# Georgia Department of Transportation Quality Assurance

### InRoads/CAiCE Survey Database(s) for Consultant QA Check

PROJECT: STP00-0002-07(020)

PI NUMBER: 122200-

SCREEN CAPTURE #1

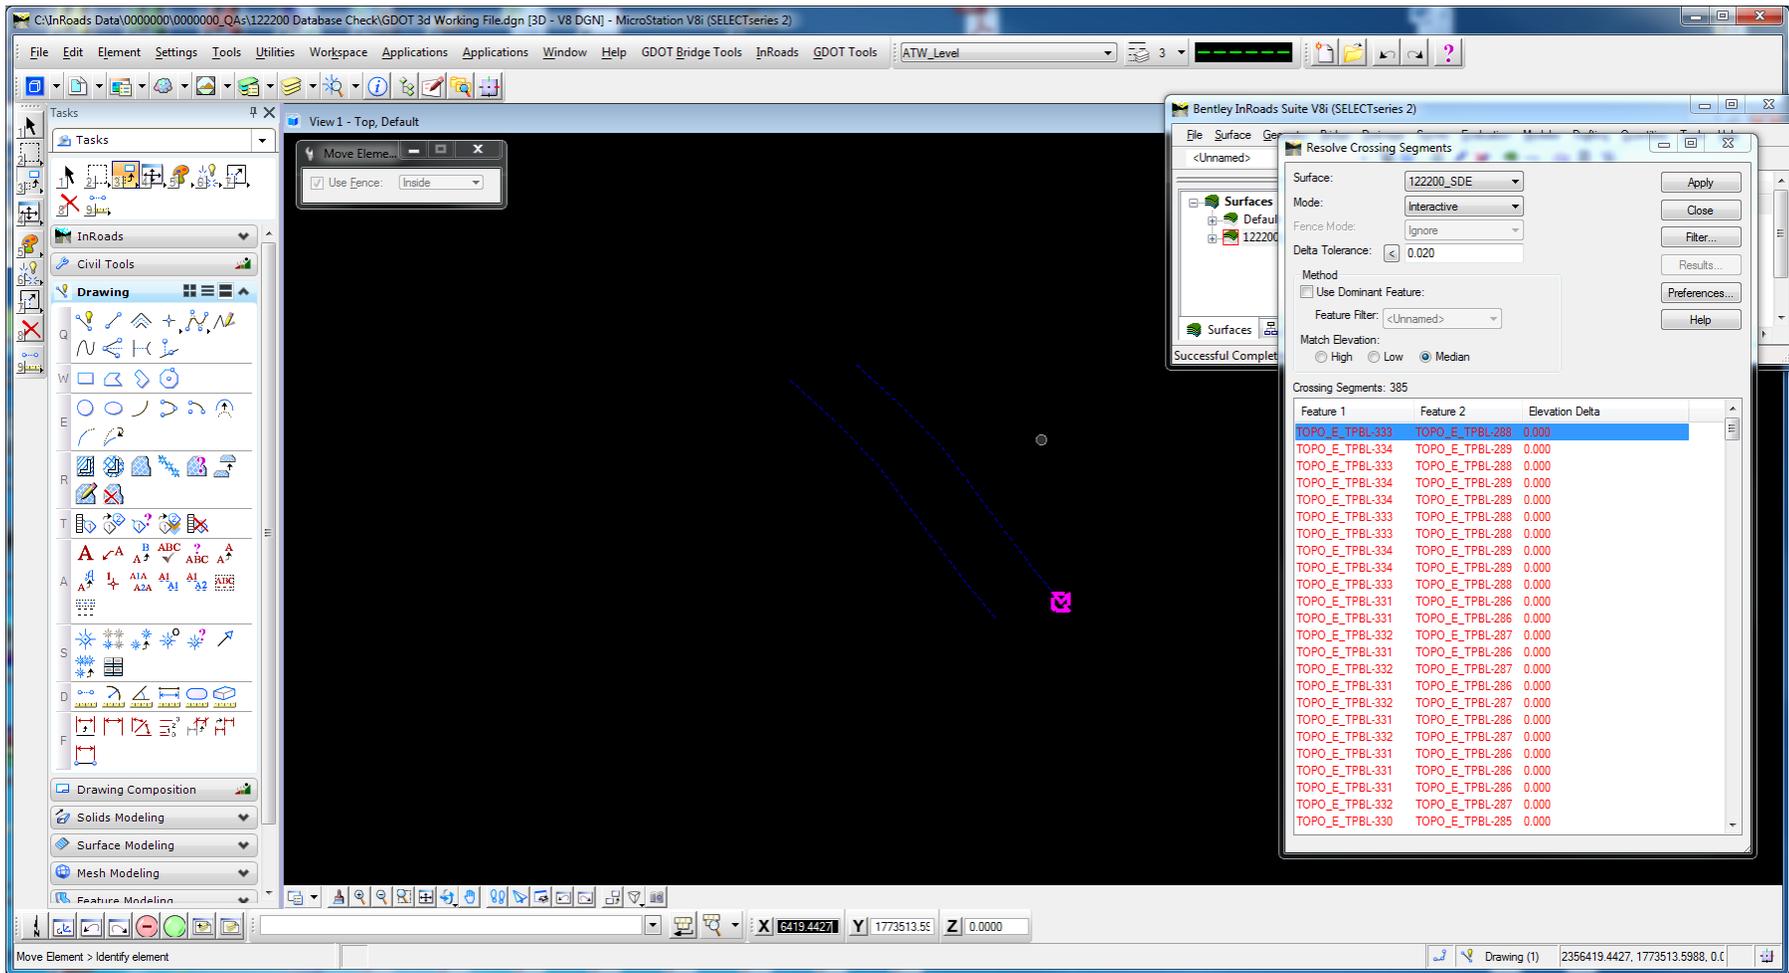
NAME OF FILE	REMARKS/COMMENTS
122200_SDE.DTM	<p><b><u>DTM</u></b></p> <ul style="list-style-type: none"><li><b><u>Please Note:</u></b> When reviewing the Resolve Crossing Segments and selecting the Interactive option &lt;0.020, there were approximately 385 mismatched elevations or overlaps with a 0.00 elevation difference. In some cases, this indicates an exact duplicate of a feature and points. Please verify if duplicates exist and if so whether or not they need to be resolved/deleted. For example, features TOPO_E_TPBL-333 and TOPO_E_TPBL-288 are reported as crossing segments with an elevation delta of 0.000. When displaying both of these features you can use the move command in MicroStation and determine that both features are exact duplicates of one another. See screen capture #1.</li></ul> <p><b><u>ALG</u></b></p> <ul style="list-style-type: none"><li>Alignments SV100, SV101 are missing point names at the beginning and/or ending of the alignments. These will need to have point names assigned and converted cogo points.</li></ul>
